PAQUETTE PLANNING ASSOCIATES LTD.
URBAN PLANNING AND LAND DEVELOPMENT CONSULTANTS

Re: Zoning By-law Amendment D02-02-21-0008 and Site Plan Control D07-12-21-0015
120 Den Hagg Drive
Phase 1

Please accept this fourth submission for site plan approval for the above referenced project as a follow up to your circulation comments received on March 6 and 16, 2023. To this end, attached are the following documents for your information:

Circulation Comments and Responses

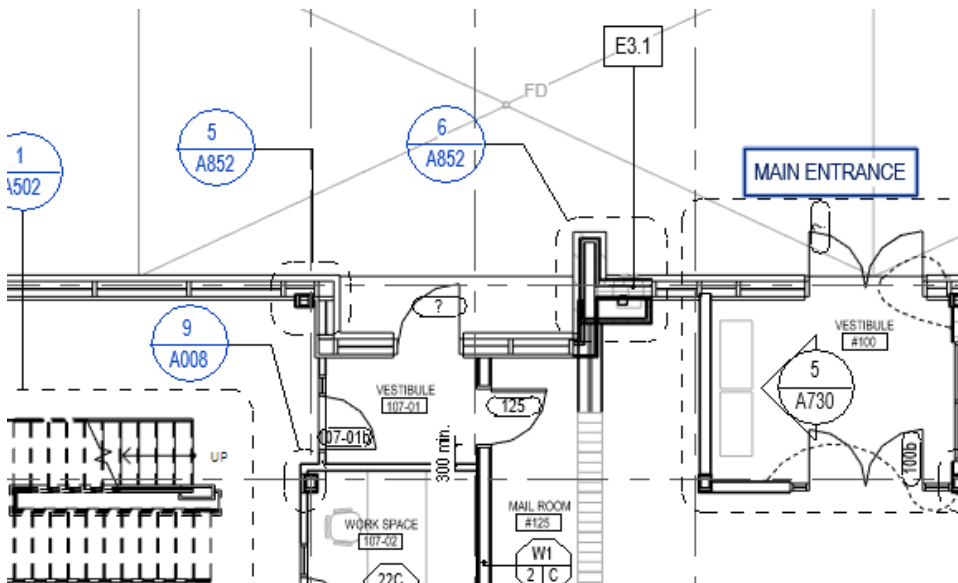
1. The eastern sidewalk along Den Haag is in disrepair with some grading issues noted. Please include the repair in the scope of works.

Response: Noted. Sidewalk to be added to scope of work for 120 Den Haag. Existing sidewalk to be removed and replaced in existing location based of city's standard details.

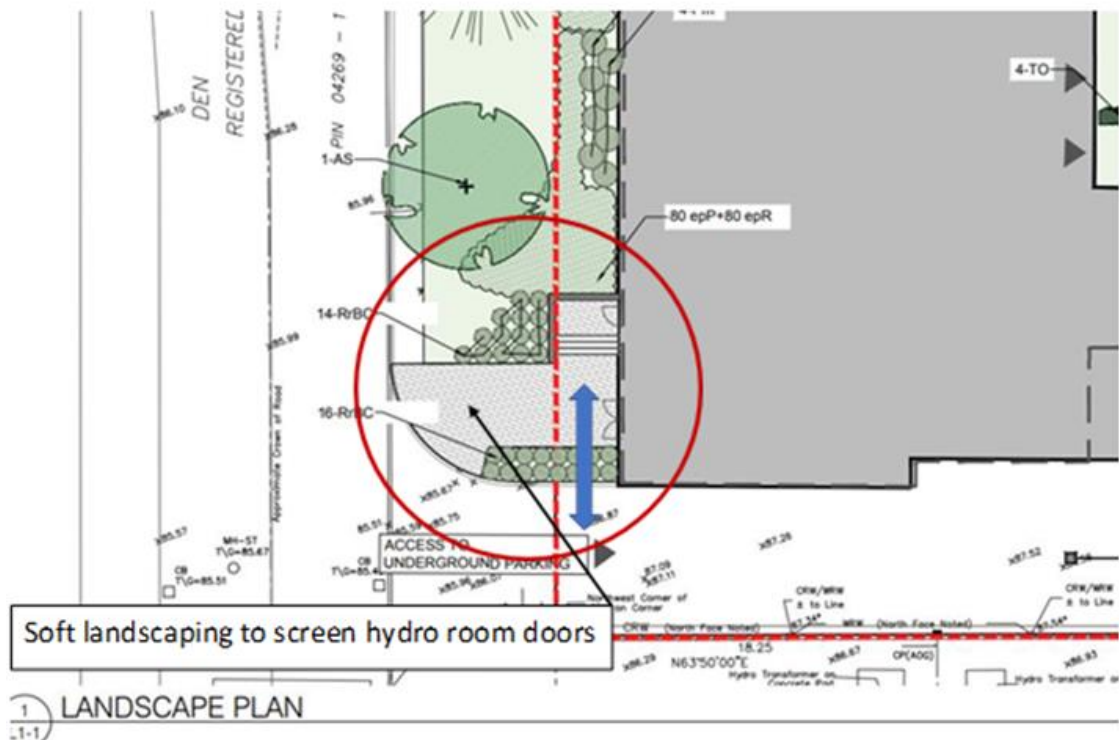
Please dimension bicycle lockups interior and exterior: space width and lengths, as well as aisle width. Ensure that it complies with Sec. 111.

- Include the number of bike lockups in each location on the site plan as it is on the landscape plan.

- Provide a detail of these lockups on plan.

- It is preferable to have these lockups in the courtyard instead of a main frontage like Montreal Road.

Response: See attached site plan. 1500mm MIN. clearance provided.

Response: See attached site plan with zoning compliance chart.

Response: See attached L3-01, Detail 3 for Bike Rack on Unit Paving.

Response: Noted.
